**DEVIATION REQUEST** (Attach diagrams, figures, and other documentation to clarify request)

A deviation from the standards of or in Section **ECM 4.3.6.3** of the Engineering Criteria Manual (ECM) is requested.

THE GLEN AT WIDEFIELD FILING NO 11  
Shallow Cover Storm Sewer (at Box Culvert)

Kiowa Project No. 19016  
October 5, 2021

# Culvert - Poa Annuua

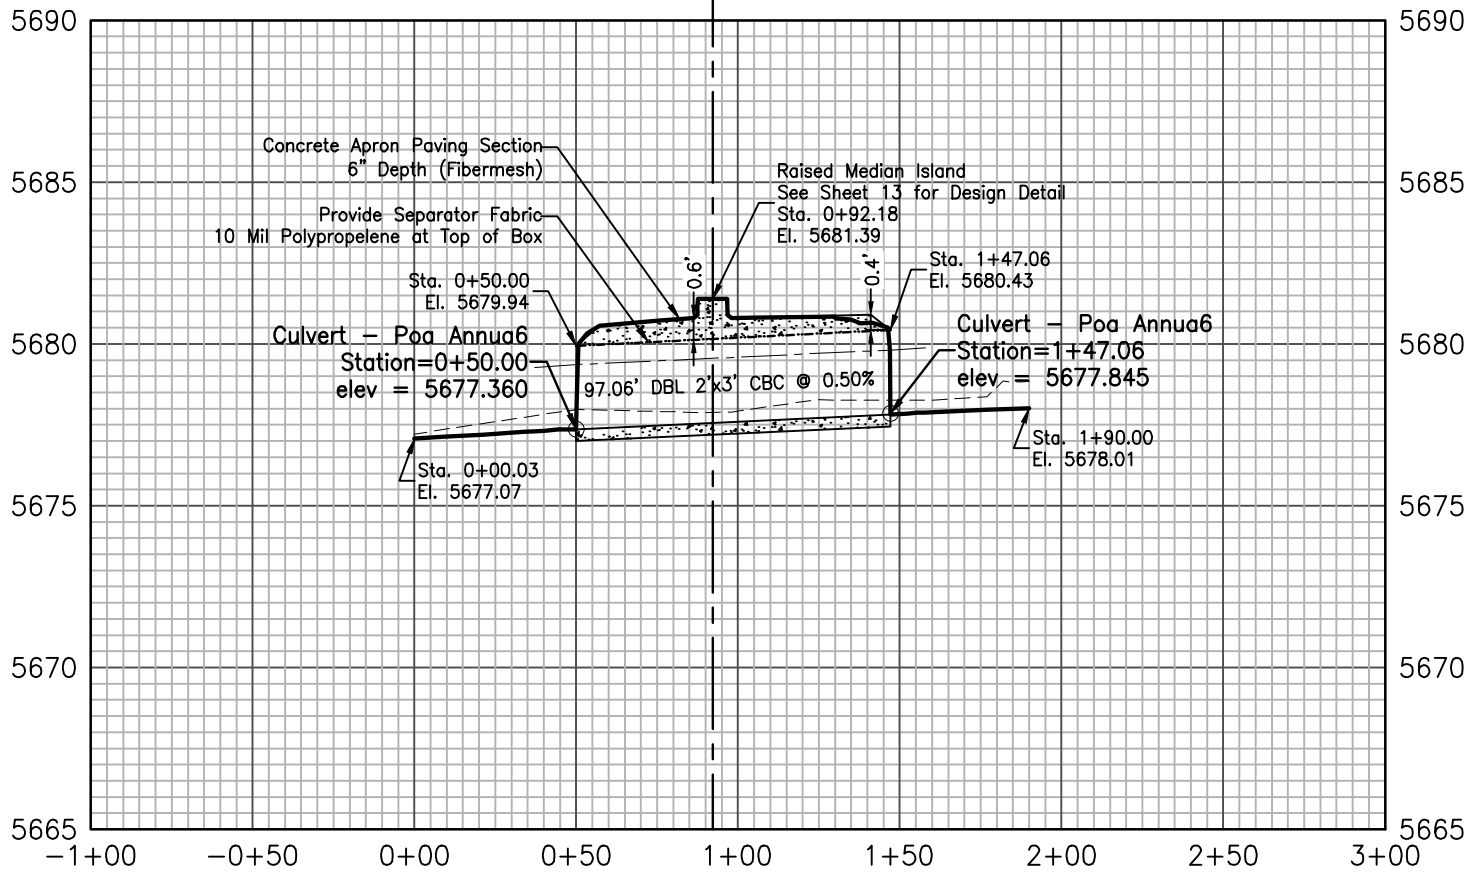
Proposing A Full-depth (6") Concrete Apron/Driving Surface atop a Box Culvert at planned Poa Annua intersection.

There will be no soil cover (0'-0") at this location. 2' of cover is required by criteria. The box culvert lid will be designed to specification AASHTO HL-93 at the time of construction/installation by a structural engineer.

Depth Adjustments Due to Public Improvement Project  
 US 24 Link Road Project impacted the subdivision's original outfall location such that several feet of outfall depth were no longer available for the site to use as a discharge point. At the time of the approved preliminary phase, the left and right side ditches were installed by others. Minimal slopes of less than 0.5% were used at these ditches. The existing ditch slope is 0.44% within the ditch section as it passes Poa Annua Street.

See Attached Exhibit 'C' for Plan and Profile of Box Culvert and for the limits of the planned concrete apron.

A certification letter from a licensed engineer shall be provided to El Paso County for review confirming that the proposed box culvert complies with the criteria indicated in ECM 2.6.9.J prior to the installation of the proposed box culvert. The box culvert shall not be installed until a specific notice to proceed has been provided by El Paso County.
